**Ministerial Planning Referral: TPM-2014-5
49-61 Coventry Street (and 26-66 Dorcas Street), Southbank**

6 May 2014

PLANNING REPORT

MINISTERIAL REFERRAL

Figure 3. Potential development opportunities identified by the applicant

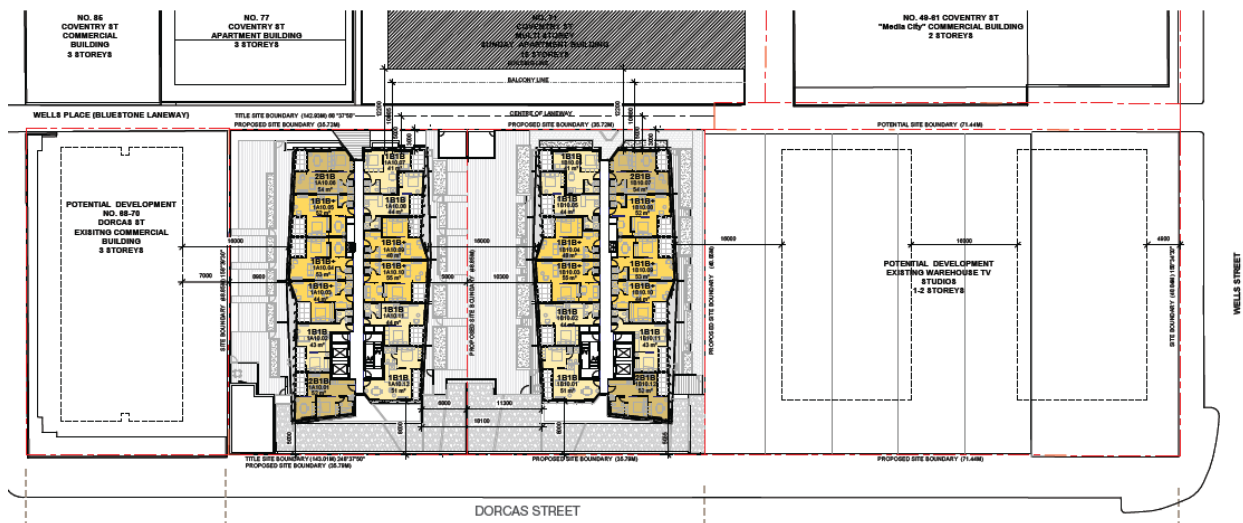
- If the 4m setback from the east boundary were approved, there should be a covenant or similar placed on the site to the east to ensure that any future tower on that site is well set back to achieve the 20m separation advocated by the DDO.
